## Flexpoint 0.5mm Pitch Break Out Evaluation

Nikhil Jali

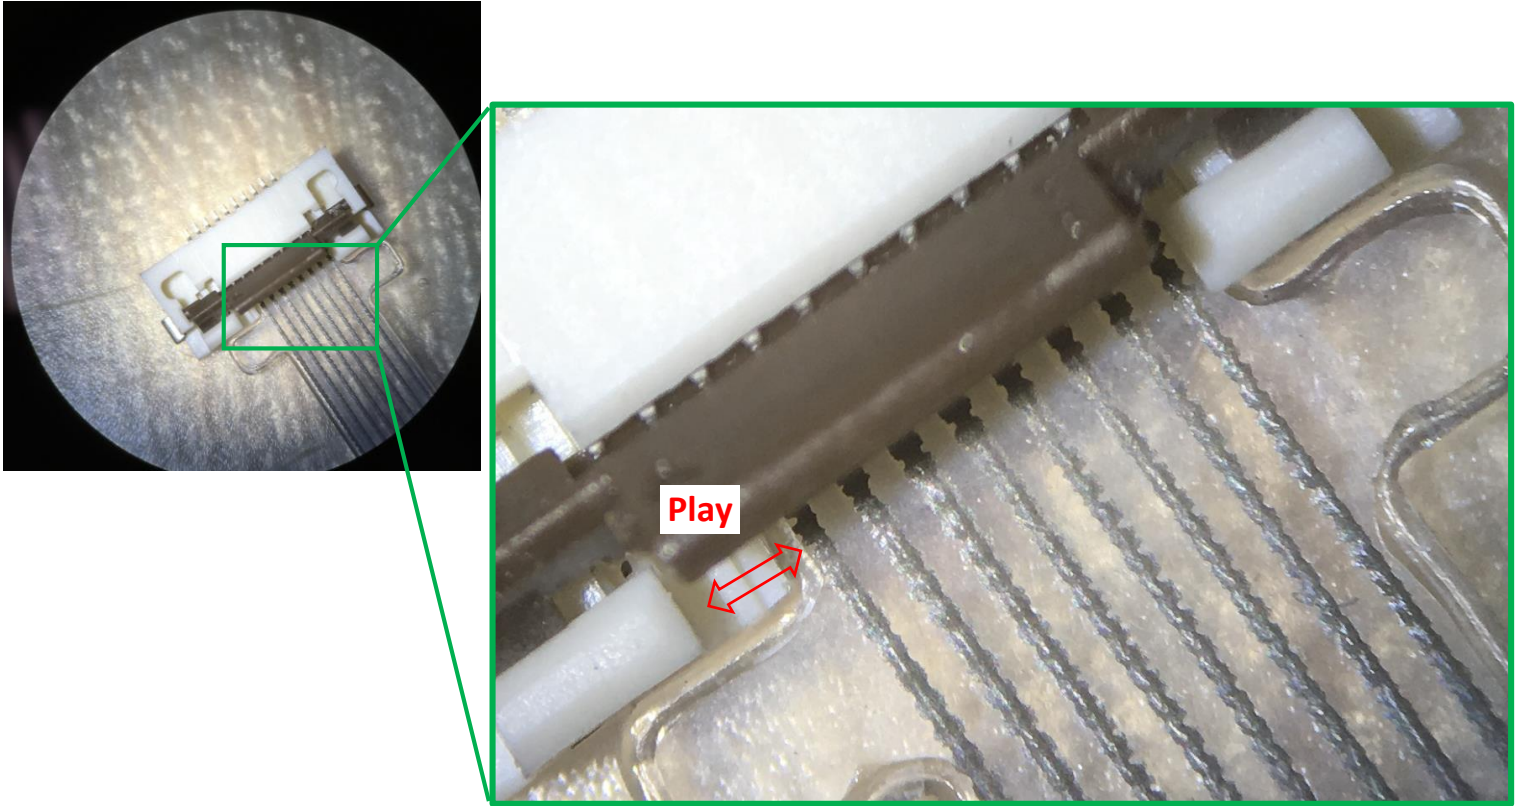
- The break-out connector received has the following mating dimensions:

The following 10-pin connector is being used: WM9203CT-ND [[Digikey Link](#)]

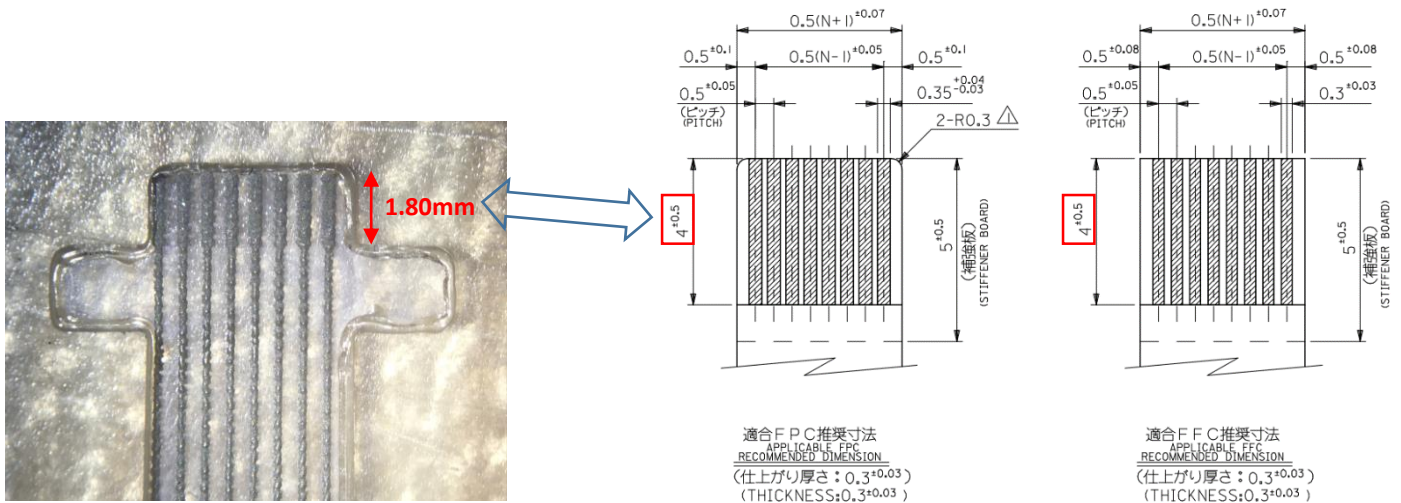
- **Pin Number Mismatch:** Since the breakout has 8pins and the connector 10, there is a mismatch of width between the breakout and connector, thus allowing for play between the two. This play is wide enough to have the terminals of the breakout connect to adjacent terminals in the connector.

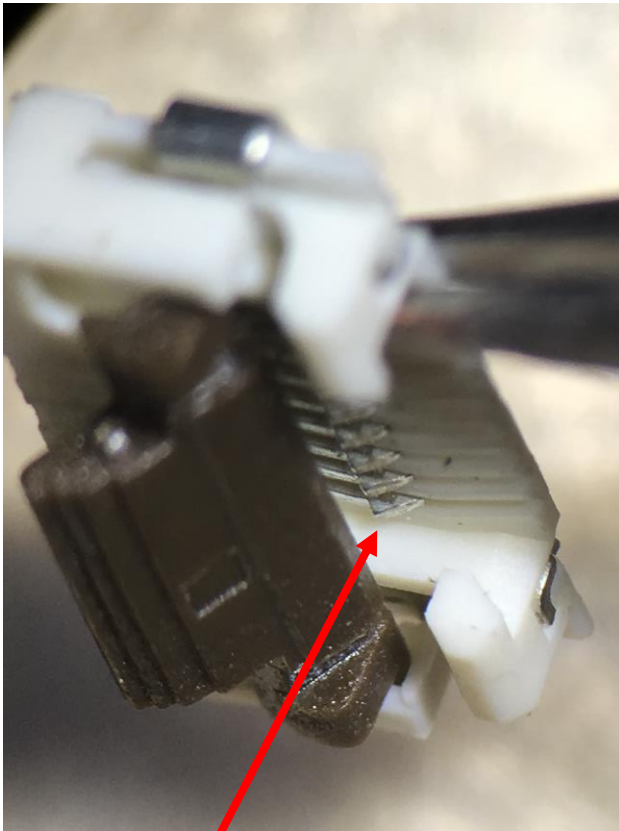
- **Insufficient Insertion Length:** The 1.80mm of insertion length is insufficient to reach the connector's terminals. The connector datasheet[[weblink](#)] describes a 4mm length (page 2).

Sharp Edges on  
Connector

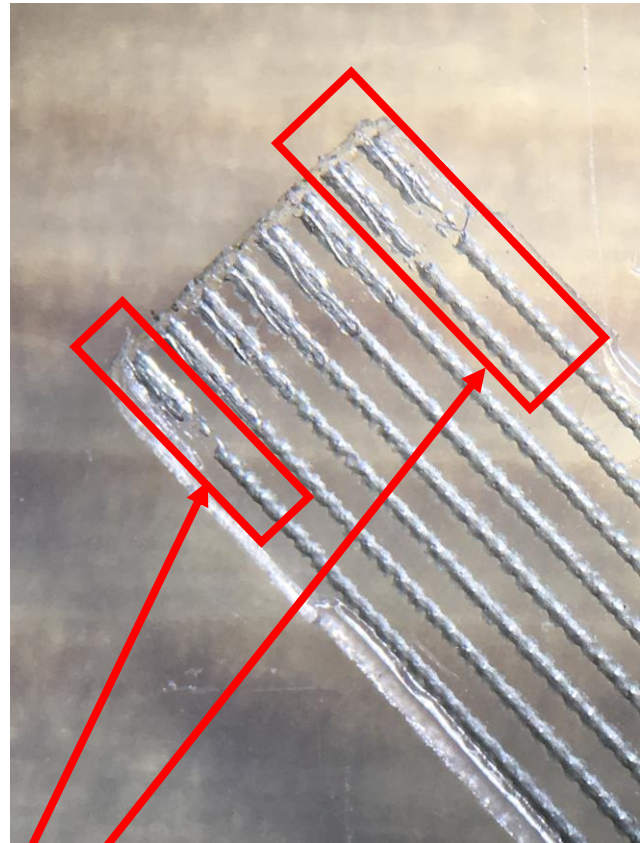
**Track Severage due to Connector:** A major risk and failure point was identified between the interface of the connector and the FPC breakout. The terminal pins of the connector were found to have sharp edges that cut into the breakout thereby severing the tracks within two uses. The pin and the severed breakout are shown below:

**SUMMARY: Connector unsuitable for use with FPC Sensor**
